Cambridge Housing Authority
MODERNIZATION OF 116 NORFOLK STREET
2ND SUBMISSION: VOLUME 2 GRAPHICS

Affordable Housing Overlay Submission
August 16, 2022

2.1 AHO Matrix Comments

NORTH YARD TERRACE

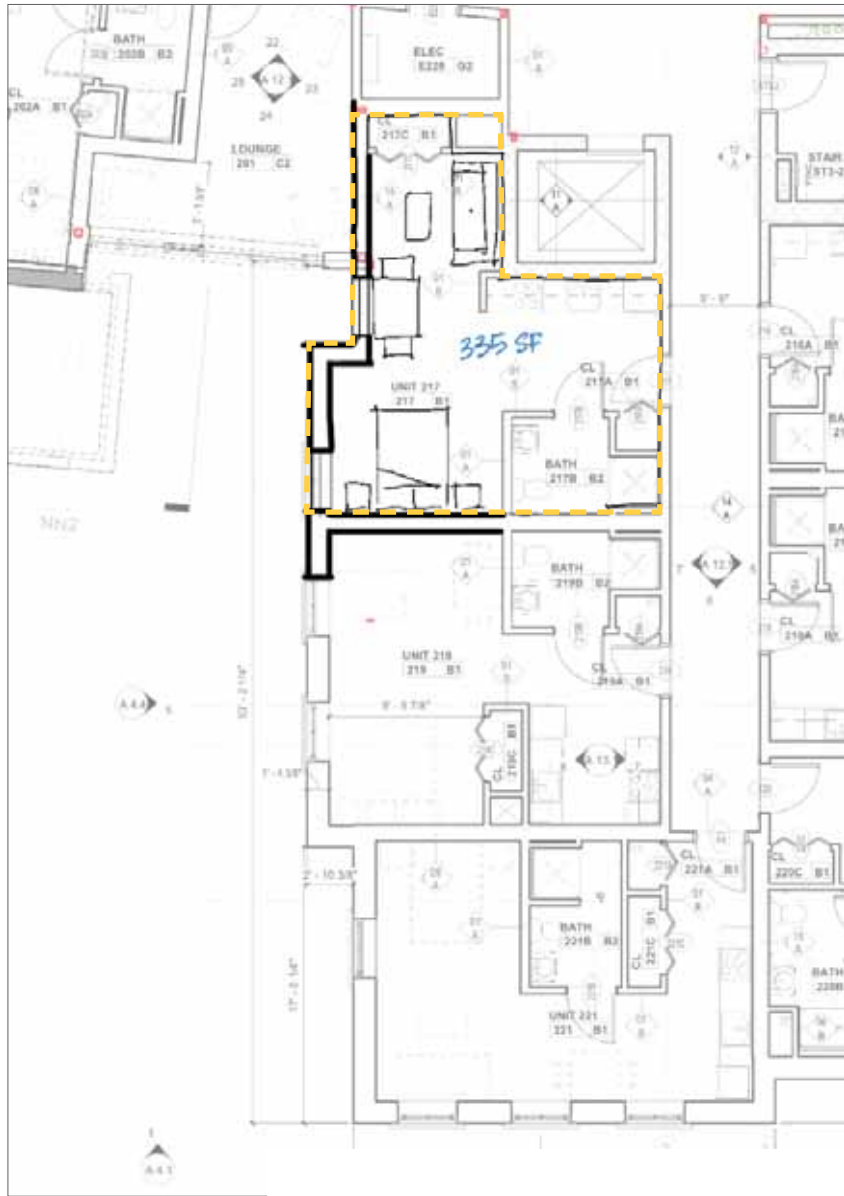
Site Design				
17	X	The deteriorated existing wooden fence atop the south brick wall is proposed to be removed. To make the benches in the south lawn that back onto the south wall (which is approximately four feet tall in that location) more inviting to use, consideration could be given to replacing the wooden fence with a lattice that vines could grow on.	CDD	Residents and neighbors expressed interest in a visual connection to the 116 Norfolk entrance from the street, so we are not introducing a lattice for vines. Instead, we are proposing a metal picket fence to site atop the masonry wall to allow more light and visibility. This will allow the entrance to be visible from Suffolk.
18		To enhance the north lawn's presence as a useful open space for residents, consideration could be given to creating steps down from the terrace to the site's north yard. The perimeter wall and gate may be sufficient to obviate potential security concerns about creating a second door to the lobby.	CDD	We considered this, however, decided against it. Having stairs up onto the terrace but no ramp would create a completely different path from yard to terrace for people with mobility aides, which would not be equitable or accessible. Furthermore, we do not want to create another entry/exit on the terrace for security reasons. We want the terrace to be used, but there are units right next to the terrace, so we do not want it to be an entry/exit point. We are, however, adding plantings in front of the terrace railing to help soften the transition between yard and the terrace.

Expanded glazing in the Connector so that it reads as bands of metal panels alternating with bands of glass at each floor.

Reduced scale of curtain wall assembly so that it no longer reads as a continuous massing from bottom to top.

Plantings in front of terrace railing help soften the transition between the yard and the terrace.

4-WINDOW PROJECTION & CONNECTOR

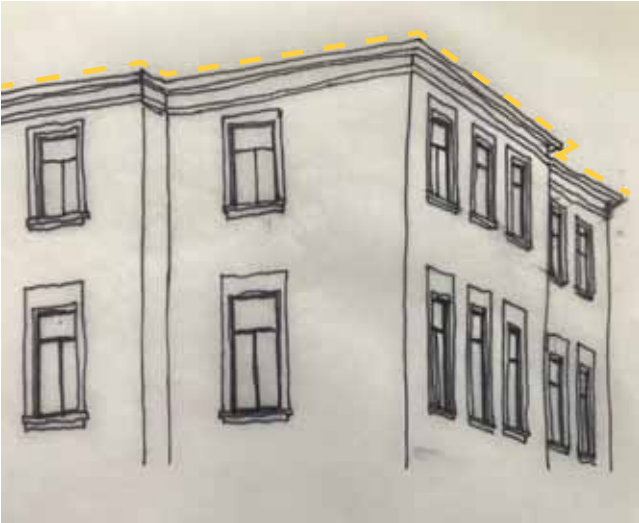
5	X	To reduce the sense of crowding created by the second and third floor projecting element on the west side of the addition, consideration could be given to raising the soffit on its underside to correspond with that of the existing south porch.	CDD	We have raised the soffit so that the underside of the soffit aligns with the underside of the porch.
6	X	Consideration could be given to providing a larger canopy above the entry door, and to aligning it with the roof of the existing south porch.	CDD	We are expanding the canopy at the entrance to 6' wide by 4'deep and adding the address ("116 Norfolk") in a bright blue above the canopy to draw further attention to the entrance. We explored aligning the canopy with the roof of the existing south porch, however, we felt that crowded the entrance and was too high above the door to protect from rain and serve as a practical canopy.
7		Consideration could be given to reducing the intrusion of the addition's second floor into the entry area. Another suggestion for the entry area was to pull back a portion of units 217 and 317 to create a three-window projection that provides additional visual space	PB	We considered this, however, shrinking the projection to three windows, removes 35 square feet from units 217 and 317, reducing them from 370 SF to 335 SF, and making them difficult to furnish. In addition, this would also make units 217 and 317 darker because the second window in the unit (closest to the connector) would be cast in shadow by the bay.

- Raised the bottom of the projection/soffit height to align with the top of porch columns to create one sightline and reduce the sense of crowding at the main entrance.
- Enlarged door (6' wide) and canopy (6' wide x 4' deep).
- Added signage on canopy to emphasize entrance.
- Increased glazing on Connector so it reads as bands of metal panels alternating with bands of glass at each floor, and reduces scale of curtain wall assembly.
- Maintained horizontality of Connector to link the existing and new buildings.
- Updated glass frit design at entrance to allow transparency while providing some privacy for residents picking up letters and packages in the mailroom.

CORNICE

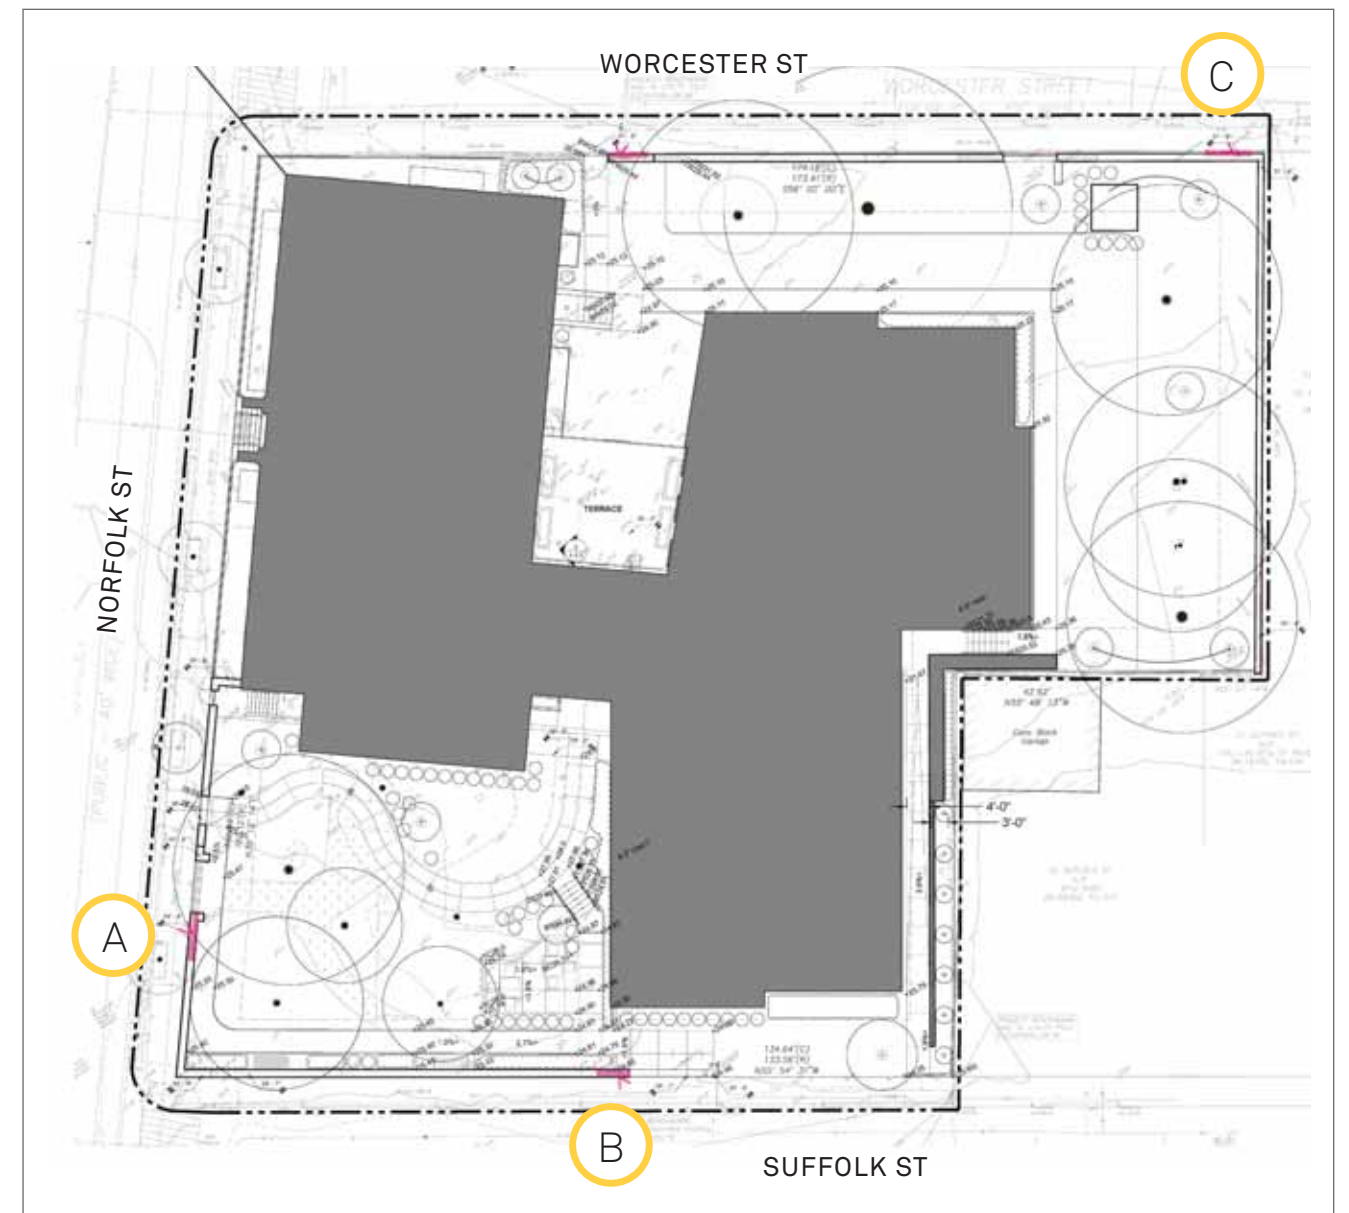
PB/CDD COMMENTS & CHA RESPONSES				
Comment #	Done?	Comment	Source	CHA Response
Building Design				
1		Consideration could be given to maintaining a cornice with a consistent projection that matches the walls below.	PB	We looked at this closely and feel that the cornice on the addition should remain as previously shown in order to relate to the existing building. Varying it with the massing would create a more contemporary look rather than speaking to the existing building. The simpler, more regular outline of the cornice helps relate the addition to the simple, regular form of the existing building. By not strictly following the path of the walls below it, the relationship between the cornice and the walls changes as one walks around the building, making the overall form more interesting.
2	X	Consideration could be given to increasing the visibility of the new entrance, and to reducing the intrusion of the addition's second floor into the entry area.	PB	We have updated the design in a handful of ways to draw more attention to the entrance and reduce the impact of the overhang at the addition: - Increased the width of the entrance to the site on Norfolk Street and left this gap in the site wall open instead of gated in order to indicate this is the main entrance. In addition, we removed a second gate on the Norfolk Street side so after construction the only gap in the Norfolk Street wall will be the main entrance. This will draw attention to the main entrance to the site. - Added ornamental tops on masonry pillars at main entrance of site only for emphasis. - Added signage including an illuminated "116" on the masonry site wall next to the gate. - Moved location of proposed public art from adjacent to the "connetor" to the exterior site wall near the entrances to the site, both making the public art more public and help drawing people's eyes to the entrances to the site. - Blended the grade of the south yard so that the landscape merges with the sole path that leads one from the entrance to the site to the entrance of the building This path is fully accessible. - Extended the canopy and added "116 NORFOLK" in blue over the canopy. - We have made the front door larger since our last submission, to announce the entrance. - Raised the height of the soffit of the projection so that it aligns with the underside of the porch. - Relocated the proposed public art from below the projection to the street and now treat the facade under the projection similarly to the area above, helping the projection blend into the rest of the addition.

As recommended by the Planning Board, we studied having the cornice line follow the massing below. After review, we propose to maintain the cornice as originally designed. The cornice takes the path that it does in order to give a simpler, more regular, outline to the addition. In this way, it helps relate the addition to the simple, regular form of the existing building. In addition, by not strictly following the path of the walls below it, the relationship between the cornice and the walls changes as you walk around the building, making its overall form more interesting.
